TECHNICAL & SAFETY COMMITTEE

INTERNATIONAL PARACHUTING COMMISSION (FAI)

Technical & Safety Information Notice No.	01/2009	W.N. 22
Date of Issue	28 January 2009	
Subject Matter and Applicability	<p>Following a riser failure on a PA Talon, the Australian Parachute Federation's Director Rigging, Jo Chitty, issued the following notice. This notice is of mandatory status for APF members, and it is being distributed by the Technical & Safety Committee of IPC to alert skydivers worldwide to the issues concerned.</p> <hr/> <p style="text-align: center;">IMPORTANT ANNOUNCEMENT FROM THE DIRECTOR OF RIGGING, AUSTRALIAN PARACHUTE FEDERATION. MANDATORY INSPECTION OF ALL 3-RINGS PRIOR TO NEXT USE</p> <p>RISER FAILURE On Sunday 18 January 2009, a PA Talon riser failed on opening. It was the left riser with RSL fitted. The reserve was deployed into the trailing main by the RSL resulting in a main reserve entanglement. Fortunately and with luck the jumper managed to attain sufficient reserve inflation to survive the landing with broken bones in his back and shoulder.</p> <p>During the investigation of his equipment it was found that the 3-ring closing loop had pulled out from under the confluence

Typical view of locking loop length

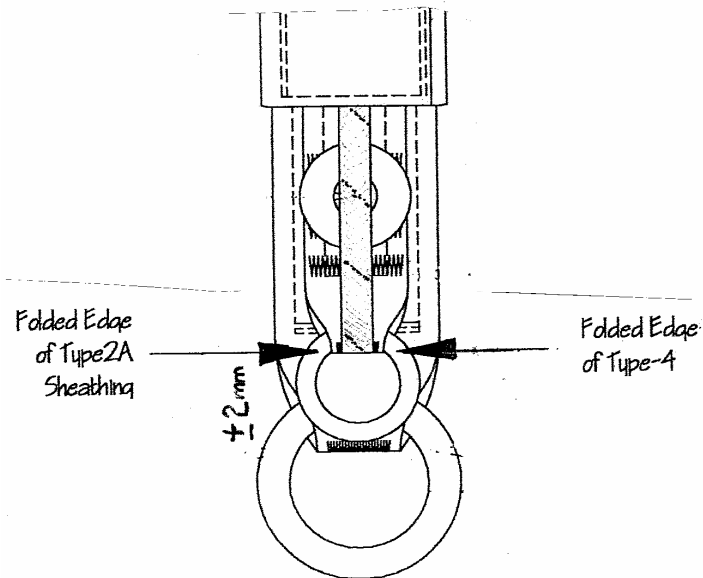
In August 2001 the APF promulgated APF Service Bulletin No APF010801-A 3-ring Inspection And Maintenance. The inspection, Part A, is designated **Mandatory**. This rig's reserve had been packed six times since the service bulletin was published, and numerous other times when the main was packed and possibly the 3-rings serviced. Had the service bulletin been applied it would have highlighted that the riser did not meet the criteria of the service bulletin; **the locking loop was too short.**

Due to the unique method of construction on this riser of bar-tacking across the loop it is probable that over a period of jumps some of the stitches had broken, due to the excessive load applied by the short locking loop until on this jump they failed completely allowing the loop to pull out of the riser, releasing it. It is impossible to visually inspect the stitching as it is covered by the confluence wrap; failure comes without warning signs. There was no kink in the left cutaway cable to warn of excessive loading. To prevent a similar event occurring especially when an RSL is fitted the following must occur.

On all solo rigs and all types of riser style, one inch type 17 mini rings, type 8 mini rings and standard type 8 with the larger rings, the length of the locking loop should be level (+/- 2mm) with the end of the fold of the webbing that retains the small ring when the riser is laid flat with some tension applied to the small ring.

It is normal for new type 17 mini risers to be tight to interlock the rings, this is because they become more pliable with use, but the locking loop must still allow the housing some play and not pull the small ring against the riser, see side view on service bulletin.

MANDATORY INSPECTION in accordance with APF Service Bulletin [APF010801-B](#)* Issued 23rd January 2009 of all 3-ring riser assemblies before the next jump. Inspection to be noted on reserve packing card and marked on inside of front riser with APF010801-B using a fine tip paint pen so it will be visible even if the risers are black.

Inspection to be carried out by a packer B or higher rating. If there is any doubt the assembly should be checked and evaluated by a rigger.
